# Interoperability with a One-Step Clock on Receive in 802.1ASbt

*IEEE 802.1 AVB TG*  
2013.11.12

# New MDSyncReceive State Machine

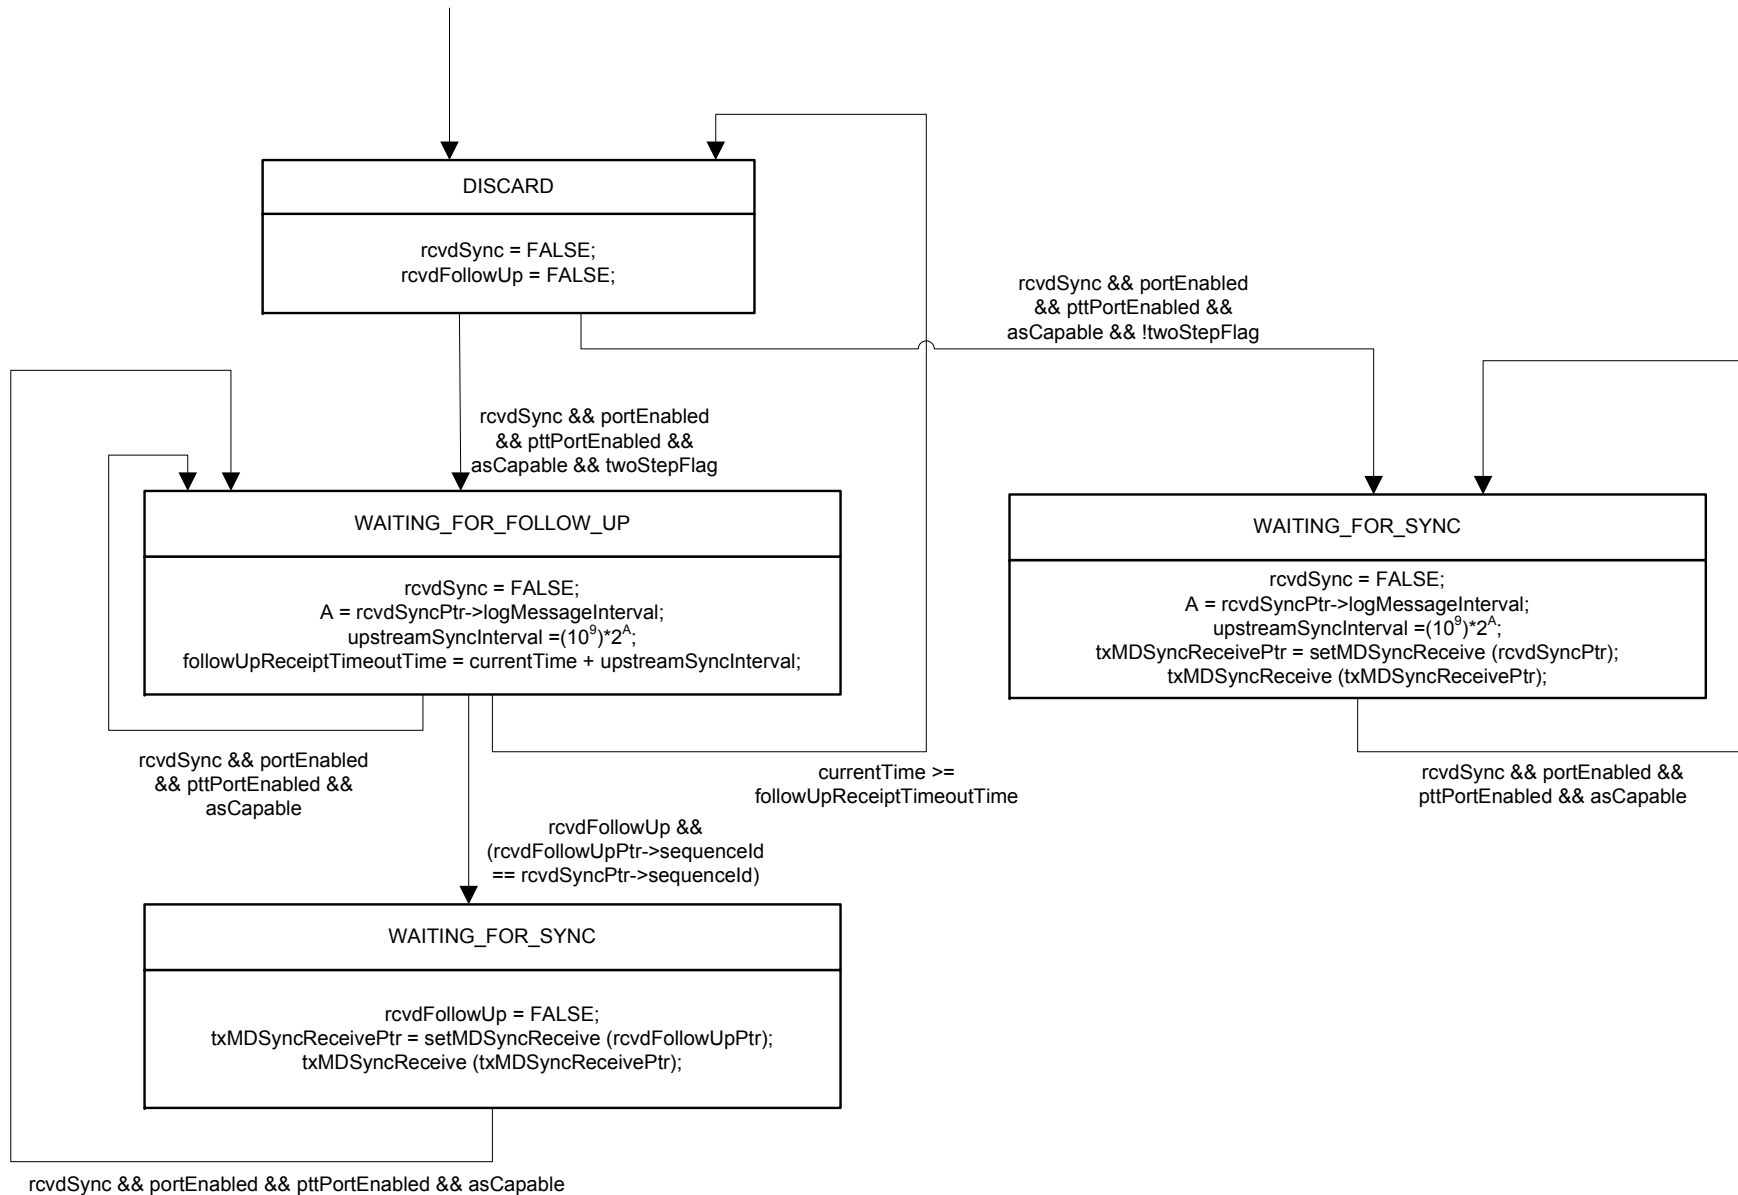
- a) If twoStepFlag of the most recently received Sync message is TRUE, followUpCorrectionField is set equal to the sum of the correctionField (see Error! Reference source not found.11.4.2.4) of the most recently received Sync message, plus the correctionField of the most recently received Follow\_Up message, else followUpCorrectionField is set equal to the correctionField of the most recently received Sync message,

- d) if twoStepFlag of the most recently received Sync message is TRUE, preciseOriginTimestamp is set equal to the preciseOriginTimestamp (see Error! Reference source not found.11.4.4.2.1) of the most recently received Follow\_Up message, else preciseOriginTimestamp is set equal to the originTimestamp (see 11.4.3.2.1) of the most recently received Sync message,
